## DISCUSSION of:

# Ground Improvement Using Preloading with Prefabricated Vertical Drains

**Bengt H. Fellenius, Dr. Tech., P.Eng., Canada; email: [bengt@fellenius.net](mailto:bengt@fellenius.net)**

Figure 1. Settlement measured at the benchmarks shifted 10 days.

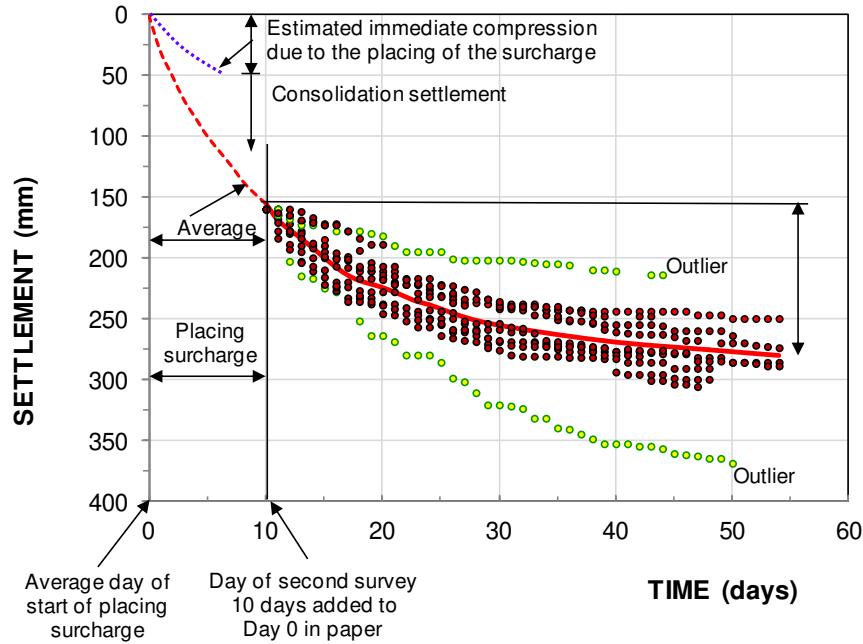
The authors report, that the first survey of the benchmarks was taken before the 3.0-m surcharge was placed across the test area. The first day of settlement measurements for the twelve benchmarks was the date of the second benchmark survey, which was carried out only when all of the surcharge had been placed to the full height over the test area. The time between the first and second surveys—and the placing of the surcharge—ranged from a few days to twenty days. Because the times between the placing of the surcharge and the second survey differed for the benchmarks, the amount of settlement that had occurred at the time of the second survey also differed between the benchmarks. This explains some of the significant scatter displayed in the authors' Figure 13. I have re-plotted the measured settlements in Figure 1 to a common starting point at the average start settlement of 160mm and added 10 days to the authors' measurement days to indicate the average duration of placing the surcharge, which took place before the second survey. During this time, immediate compression and some consolidation will have occurred. As indicated, I estimate the immediate compression to be about 50 mm. I have also added an average curve and extrapolated it back to the origin (the average excludes the two outlier records). All benchmarks appear to show that most of the consolidation had developed at the time the last survey was made.

Figure 2. Settlement measured at the benchmarks normalized to the average end values.

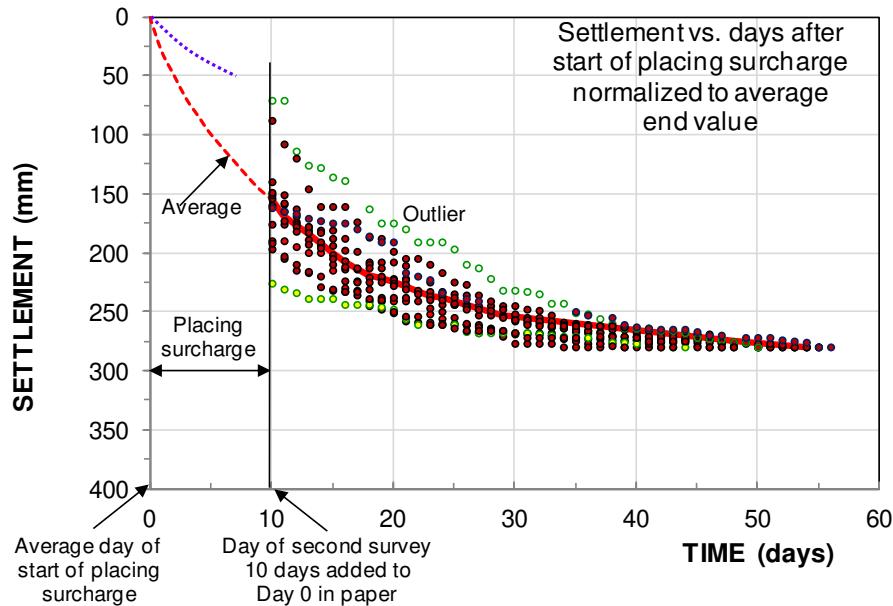
Figure 2 shows the measured final settlements are normalized to the average final settlement (280 mm). There is still much scatter between the curves, but now the approximate start date for each curve can be obtained by sliding the curves left or right until the best agreement to the average curve is obtained as shown in Figure 3. The removal of much of the scatter—the agreement between the time-settlement curves—is of course to some extent fictitious as the benchmark measurements cannot be expected to be all that similar; a natural variation must have taken place, not least with regard to the thickness of the soft clay layer. However, I believe that the figure suggests a reasonably realistic day for the start of placing the surcharge.

Figure 3. Settlement measured at the benchmarks adjusted to obtain the approximate start day.

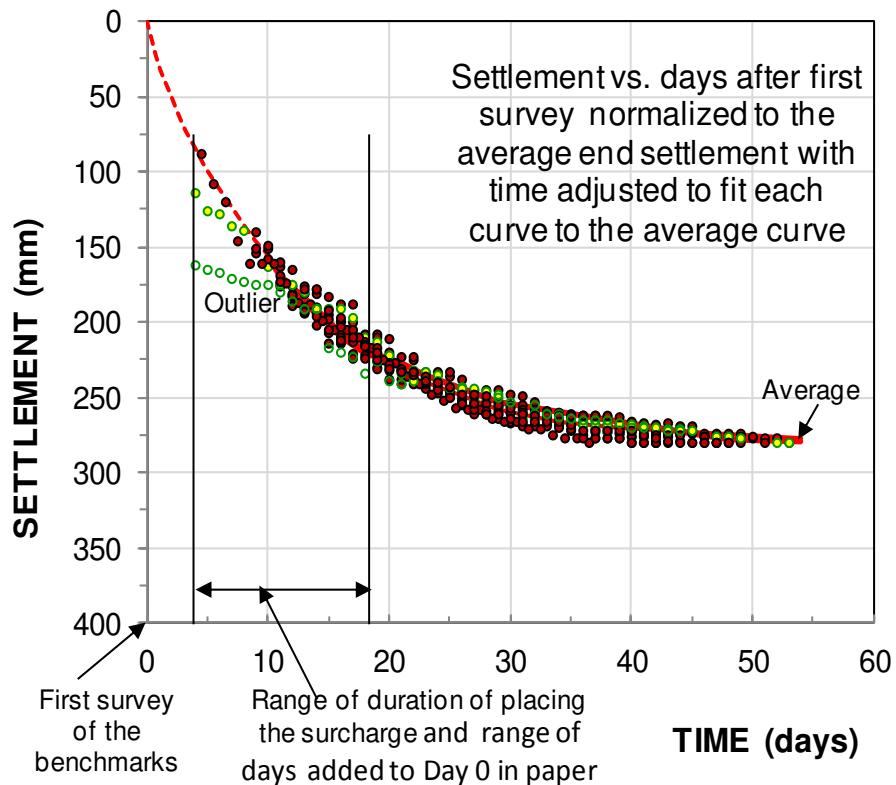
The average curve shown in Figure 3 can now serve as reference to a back-calculation of the time-settlement development for the wick-drain project to determine compressibility and coefficient of consolidation of the soil layers. The back-calculation consists of applying the theory of pore pressure dissipation in fine-grained soils (consolidation) due to radial flow (Barron 1948, Kjellman 1948, and Hansbo 1960; 1979) is based on radial flow toward a circular drain in the center of a cylinder of homogeneous soil with an impervious outer boundary surface). The theory is summarized in the Kjellman-Barron formula, Equation 1. The Kjellman-Barron formula is based on the assumption of horizontal (radial) flow only and a homogeneous soil.

Figure 4. Average measured and calculated settlements.

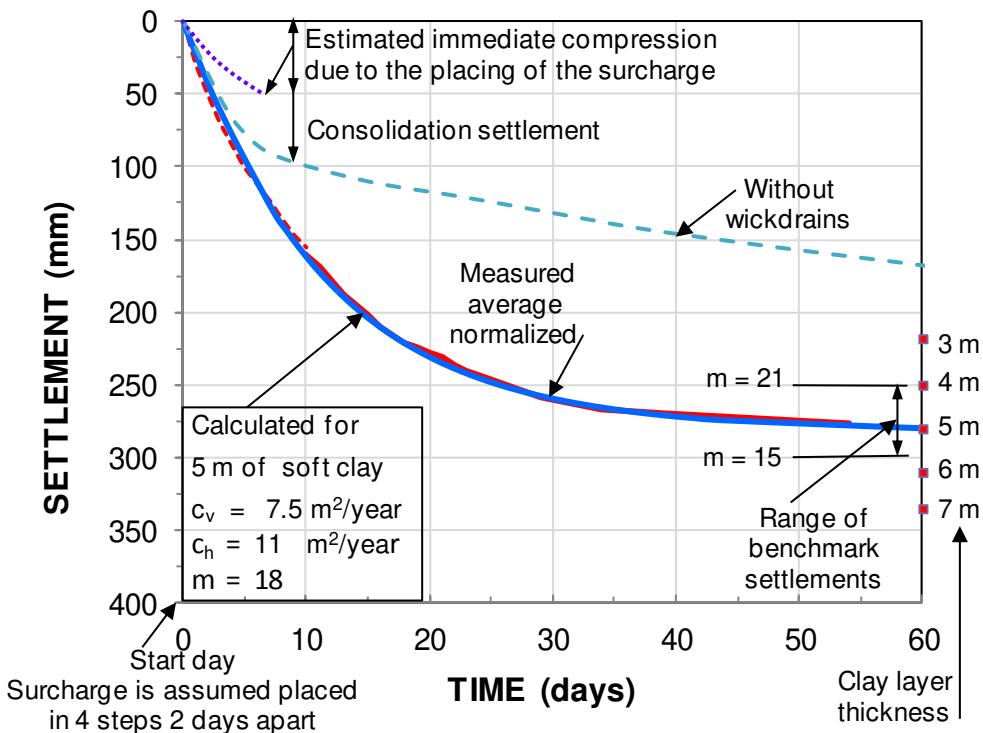
The results of the back calculation are shown in Figure 4 together with the average curve of the measurements. In order to show the sensitivity of the clay layer thickness and modulus number, the figure also shows the final settlement for soil layer thickness ranging from 3 through 7m and the final settlement resulting from modulus numbers of 15 and 21. The figure also shows the settlement during the first 60 days that would have occurred had there been no wick drains (for this input, I used the authors' 7. 5 $\text{m}^2/\text{year}$   $c_v$ -coefficient).

Considering that my data reduction is quite different to that of the authors, my back-calculated  $c_h$ -coefficient (11 $\text{m}^2/\text{year}$ ) agrees well with the authors' laboratory-established value (14 $\text{m}^2/\text{year}$ ). The difference could be taken to represent the effect of a smear zone. However, considering all the uncertainties involved, I believe the agreement to be entirely fortuitous.
